EXTERIOR REMODEL

2550 BROAD STREET

Subject: ARCH-0528-2019 (2550 Broad Street)
Review of a 1,386-square foot building addition and facade remodel of an existing commercial structure. Project includes the removal of a kiosk structure near the corner of Broad Street and Francis Avenue and additional landscaping

CONDITIONS
OF APPROVAL

SITE PLAN
1/8" = 1' - 0"

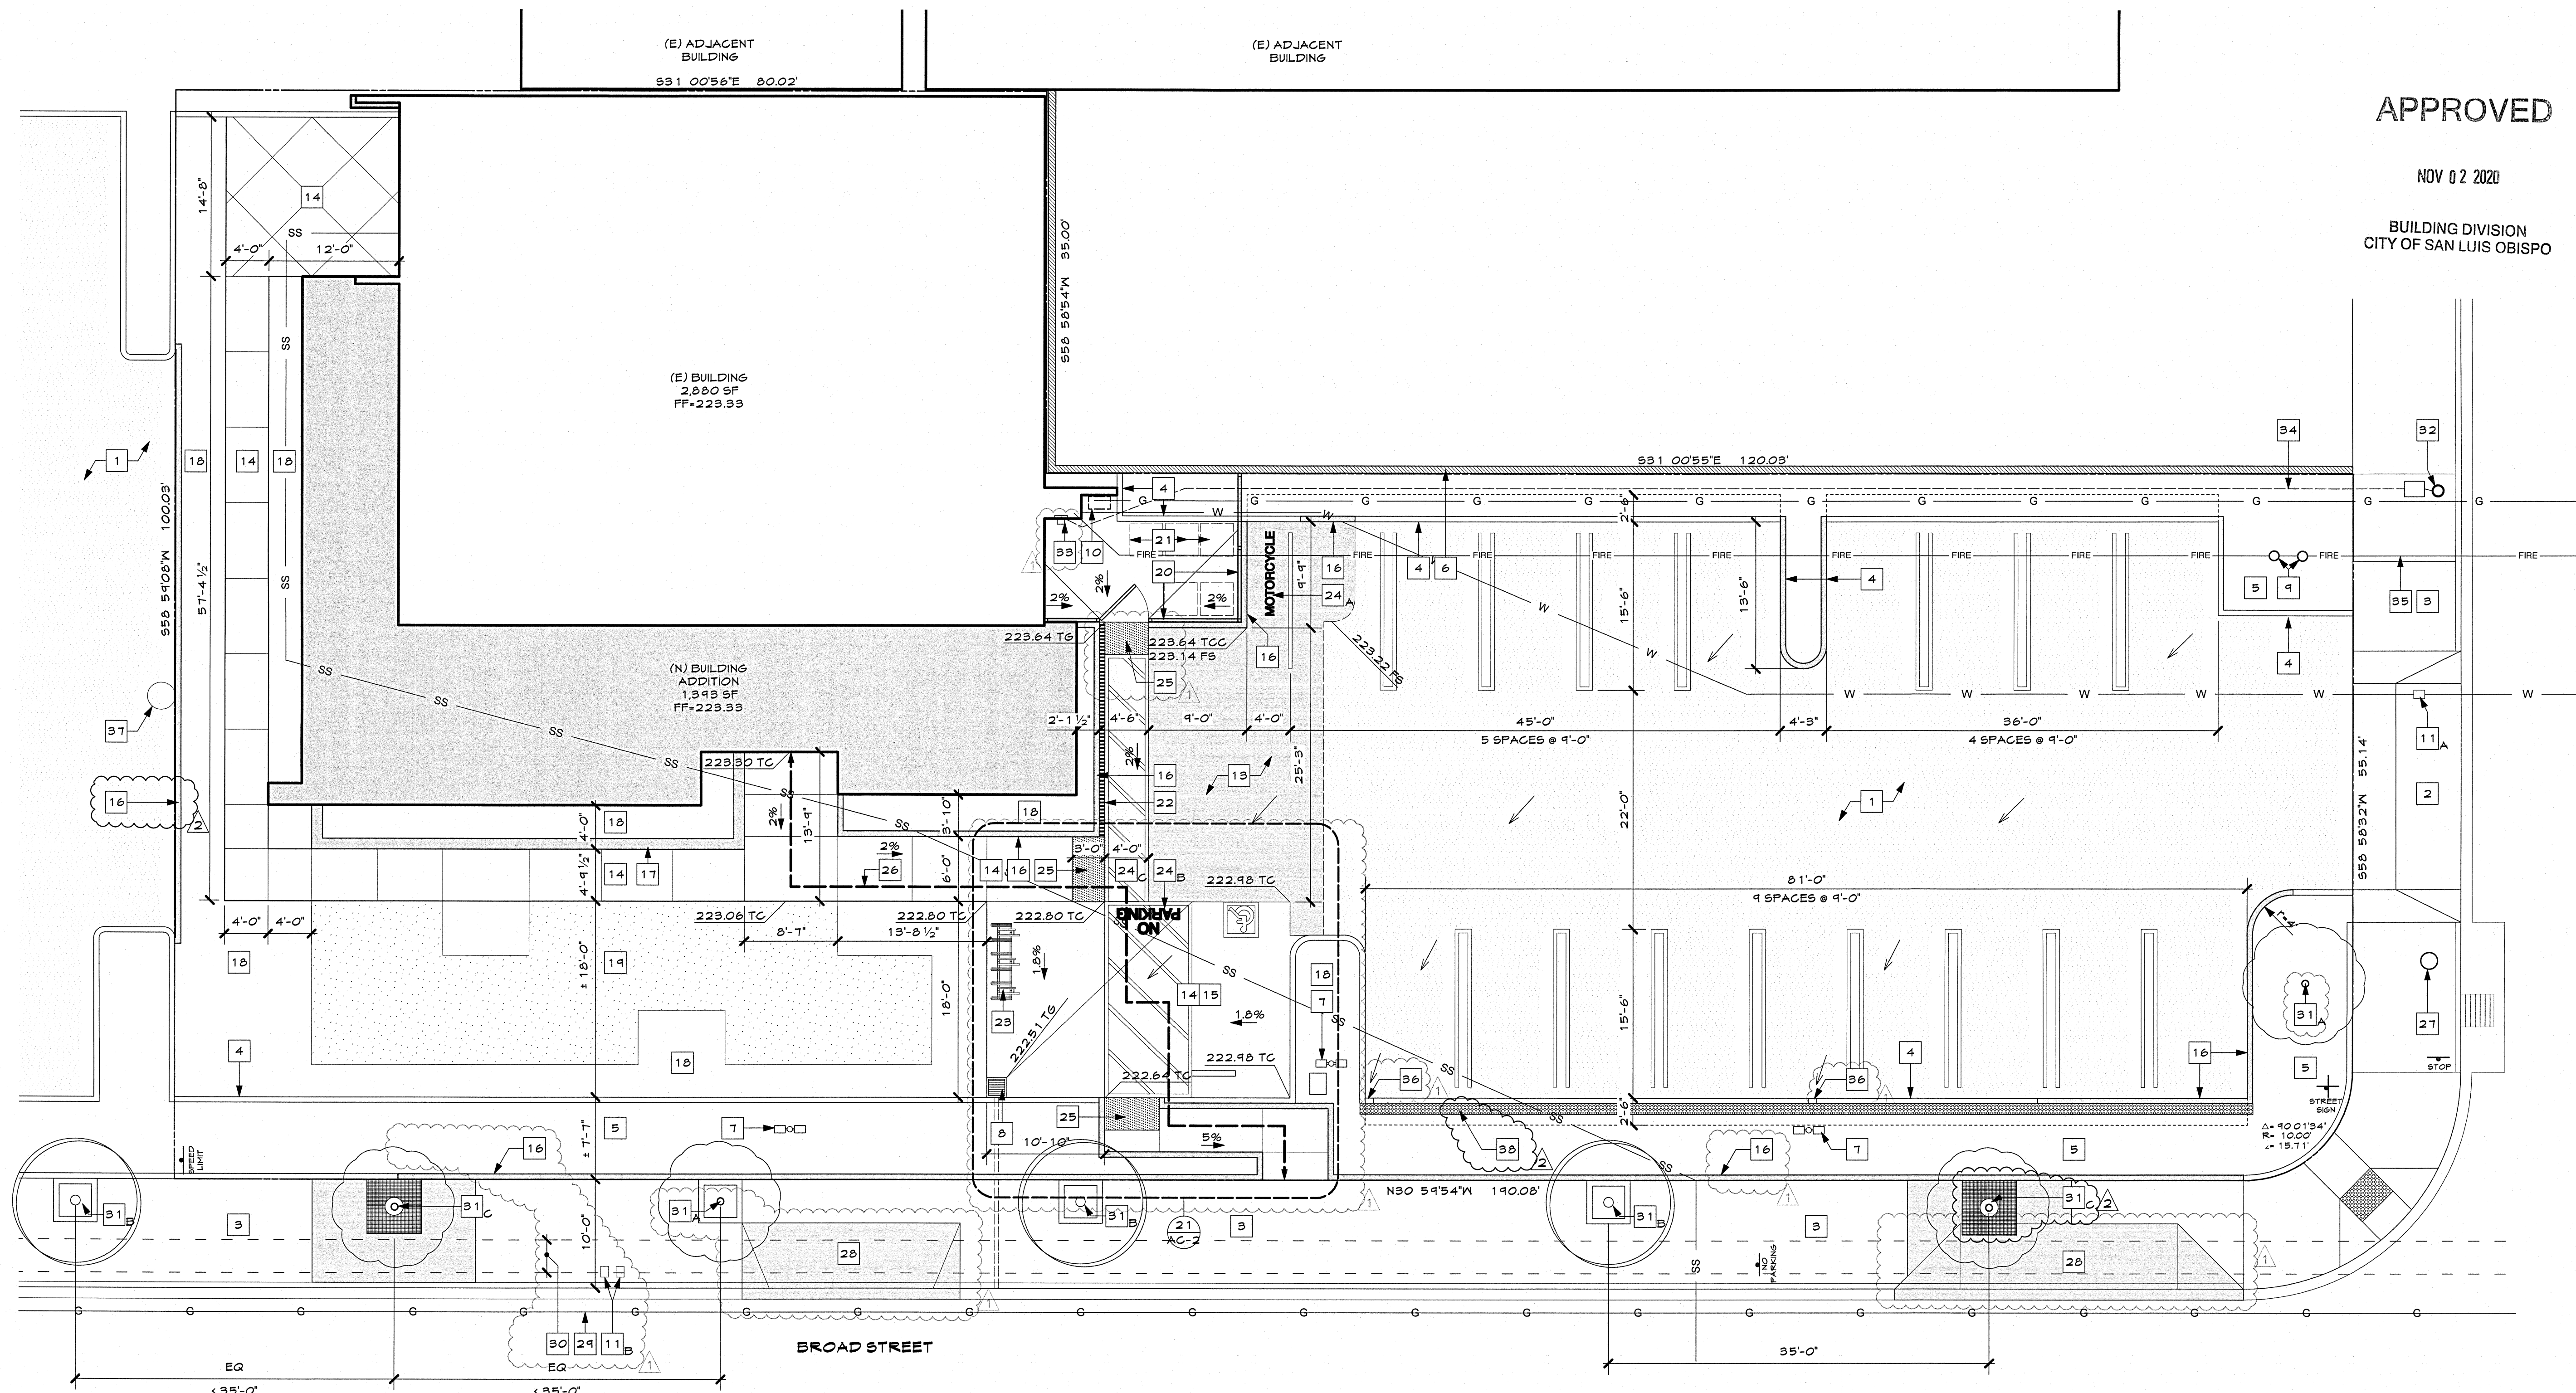
- The building plan submittal shall show that the existing driveway approach on Francis Street complies with the current American Disabilities Act (ADA) standards. *See Sheet AC-1*

- The building plan submittal shall show the two existing driveway approaches on Broad Street to be abandoned and replaced with curb and sidewalks per city standards. *Existing driveways are shown on the Site Plan and indicated by Note #2B on Sheet AC-1*

- With the abandonment of the driveways the building plan submittal shall show new street trees with 5'x 5' tree wells for areas of 10' sidewalks along Broad Street. The building plan submittal shall show all new tree wells to be located at the back of curb per city standards #8130. *As an alternative, subject to the approval of the Public Works Director, the City would support a 3.5' Parkway with required street trees planted in the Parkway, which shall include irrigation for plantings in the Parkway. The City would support the removal of the* *New street trees are shown on the Site Plan and indicated by Note #9.1 on Sheet AC-1. Also, see Landscape Notes on Sheet AC-1.*

- The building plan submittal shall correctly show the existing and proposed frontage improvements and sidewalk furniture located within the public right-of-way, including utility vaults, under sidewalk drains, meters, tree wells, relocations and abandonments. *See Site Plan on Sheet AC-1 for locations of existing improvements.*

- The building plan submittal shall include a complete site utility plan showing all existing and proposed on-site and off-site utilities. Show the existing Post Indicator Valve (PIV) double-check assembly for the existing fire sprinklers. Assembly upgrades and clearances including and not limited to the PIV may be required. *See Site Plan on Sheet AC-1 for locations of existing utilities and PIV.*

- The building plan submittal shall show onsite run-off from the parking lot to be upgraded to provide some level of treatment, to the satisfaction of the Public Works Director. *Onsite run-off is shown as being directed to a landscape area. See Note #36 on AC-1.*

- The building plan submittal shall show the existing retaining curb at the back of the sidewalk on Broad Street to extend to the Francis Street curb ramp to prevent the planting area/slope bank soil from washing onto sidewalk. *Retaining curb extension is shown on Sheet AC-1, indicated by Note #16.*

- The building plan submittal shall show all required street trees. Street trees are required at a rate of one 15-gallon street tree for each 35 linear feet of frontage. The City Arborist shall *New street trees are shown on the Site Plan and indicated by Note #9.1 on Sheet AC-1. Also, see Landscape Notes on Sheet AC-1.*

51 ENLARGED PARKING PLAN
1/8" = 1' - 0"

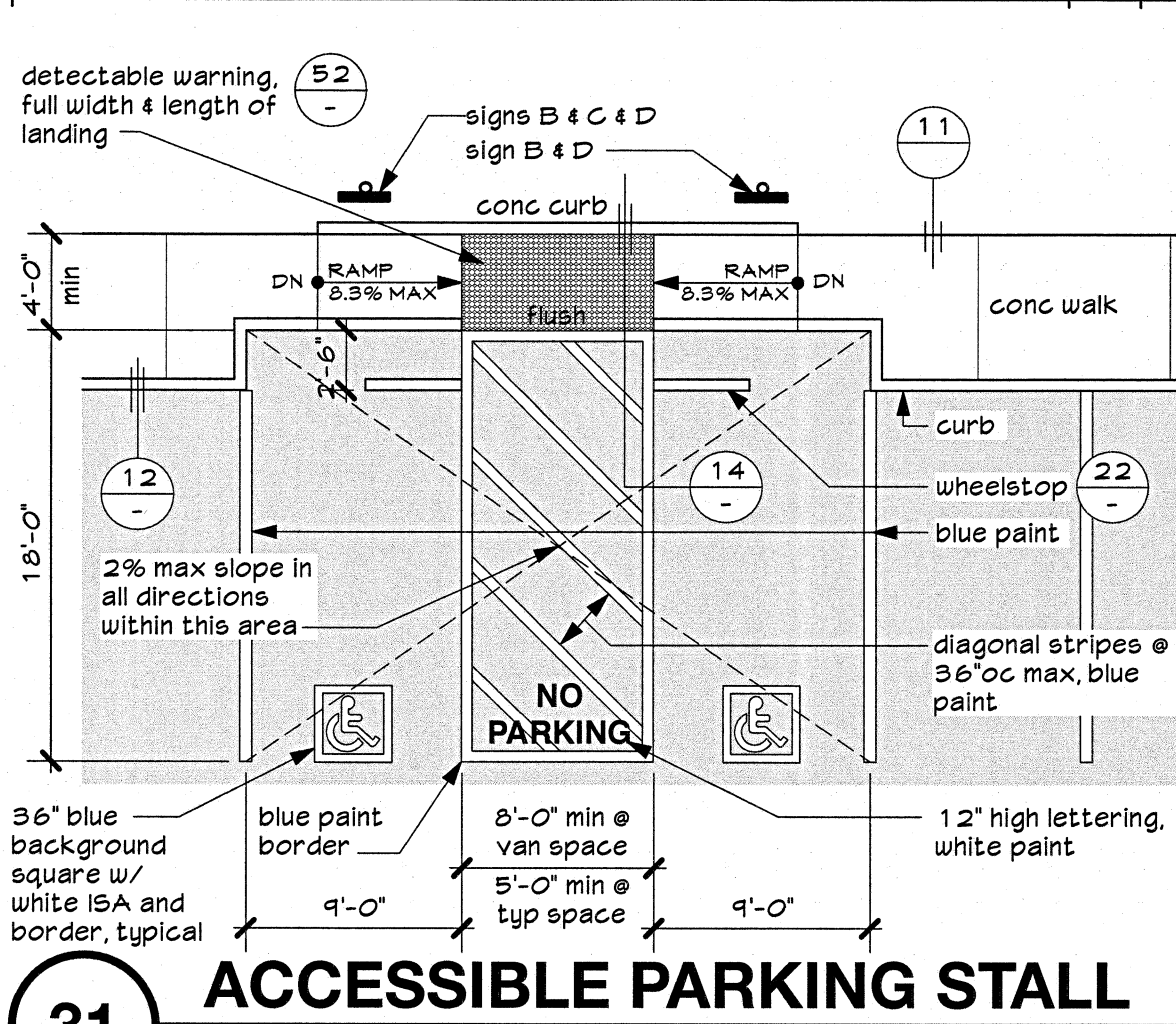
- The building plan submittal shall comply with the Parking and Driveway Standards for dimensions, maneuverability, slopes, drainage, and materials. Pervious paving materials are recommended for surface parking lots for water quantity and/or quality control purposes and within the area of the root zone/tree canopy of existing and proposed tree plantings. *See Enlarged Plan and details on Sheet AC-2.*

- The building plan submittal shall include the limits of grading and drainage to accommodate the path of travel from the public right-of-way per the Building Code, if grading is required or proposed. *See Enlarged Plan on Detail 5.1 on Sheet AC-2.*

32 TRASH ENCLOSURE
1/8" = 1'-0"

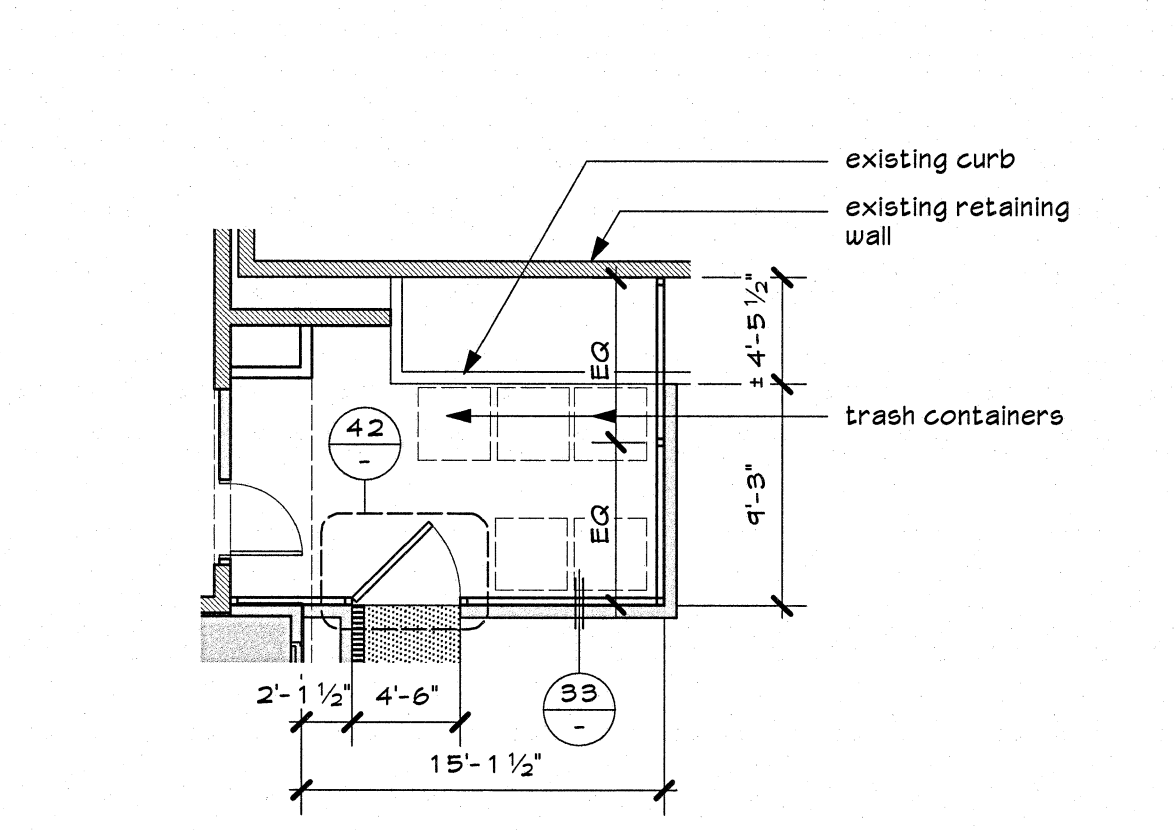
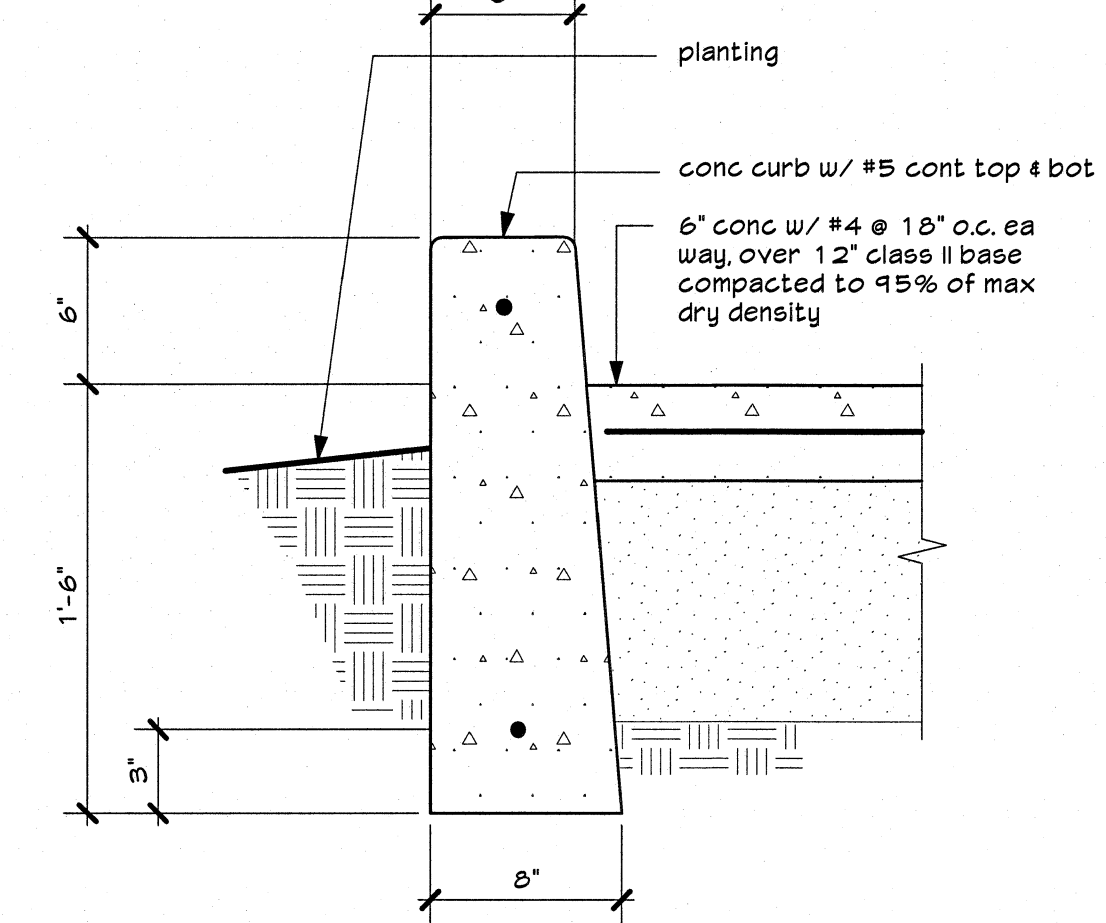
- Provisions for trash, recycle, and green waste containment, screening, and collection shall be approved to the satisfaction of the City and San Luis Obispo Garbage Company. The respective refuse storage area and on-site conveyance shall consider convenience, aesthetics, safety, and functionality. Drainage from the trash enclosure shall be treated in accordance with City Engineering Standard 1010.B and shall be included in the Post Construction Stormwater Regulation compliance summary. *Trash enclosure is shown on the Site Plan on Sheet AC-1. Materials are indicated on the elevations on Sheet A-3 and Detail 4.2/AC-2.*

Trash enclosure is shown on the Site Plan on Sheet AC-1. Materials are indicated on the elevations on Sheet A-3 and Detail 4.2/AC-2.
